Awel y Môr Offshore Wind Farm

Marine Mammal Clarification Note

Deadline 1

Document Reference: 1.2

Figure 1: Population trajectory for both the impacted and un-impacted harbour porpoise population resulting from 201 days of piling disturbance

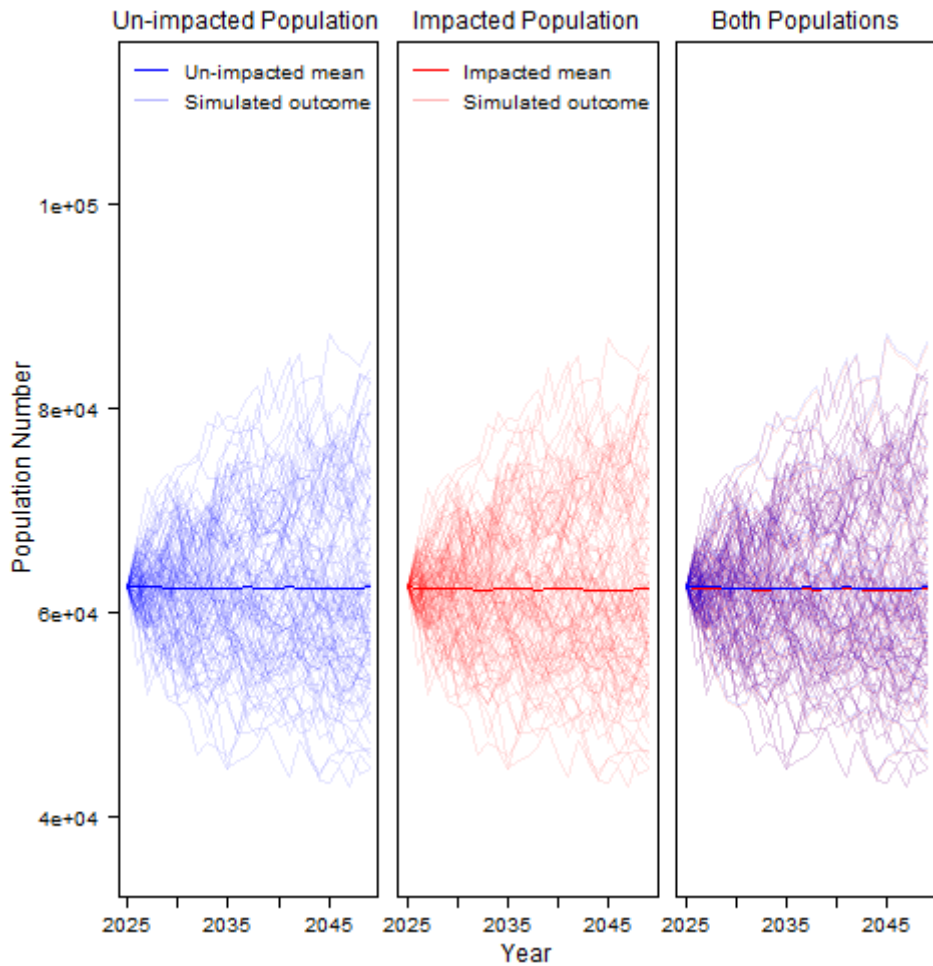
26 NRW stated: *“In order to allow a more comprehensive analysis of PTS and disturbance, NRW considers that additional modelling should be carried out and additional model details provided in order to inform assessments of underwater noise and PTS onset. This includes carrying out Interim Population Consequences of Disturbance (iPCoD) modelling for harbour porpoise disturbance and PTS injury, including modelling parameters used”*.

- 28 Using the SWF density estimate, the proportion of the MU predicted to be impacted reached 3.38%, however, since this density estimate was considered to be highly precautionary, iPCoD was not run. For completeness, this has now been run and the results presented here. The following parameters were used:

- ▲ Demographic parameters: as per Sinclair et al., (2020)
 - ▲ Disturbance to 2112 porpoise per day
 - ▲ 201 piling days
- 29 Even under this worst-case scenario (using the highly conservative density estimate), the population size of the impacted population remains as 99.9% of the size of the unimpacted population after 1 year of pile driving, and 99.8% of the size of the unimpacted population at the end of the 25-year simulation (Figure 1). The conclusions presented in the marine mammal impact assessment (ES Volume 2, Chapter 7; AS-026) therefore remain the same:
